ATTACHMENT B

**PROPOSED PAGE CHANGES TO TECHNICAL SPECIFICATIONS
FOR OPERATING LICENSE NPF-11 AND NPF-18**

BASES FIGURE B 3/4.6.2-1

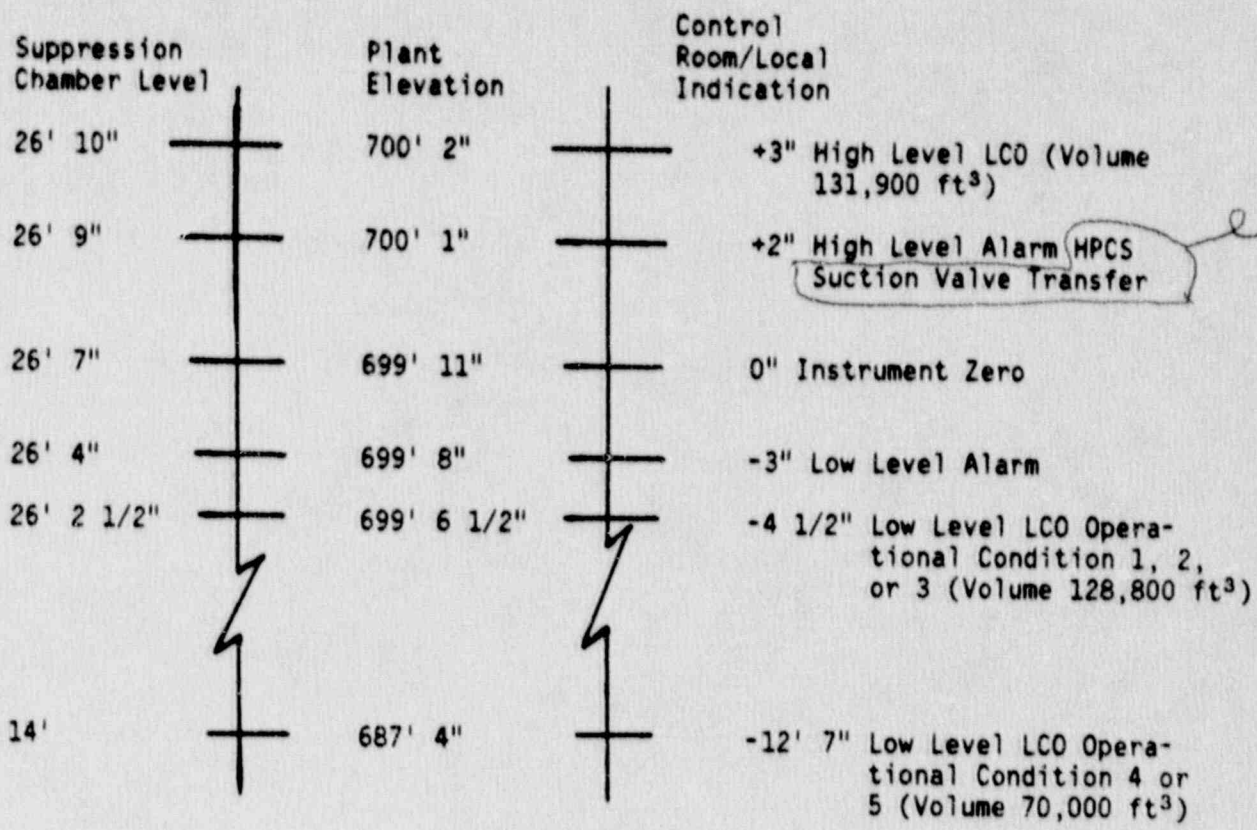
In OPERATIONAL CONDITION 4 and 5 the suppression chamber minimum required water volume is reduced because the reactor coolant is maintained at or below 200°F. Since pressure suppression is not required below 212°F, the minimum water volume is based on NPSH, recirculation volume, vortex prevention plus a 2'-4" safety margin for conservatism.

SUPPRESSION POOL LEVEL SETPOINTS
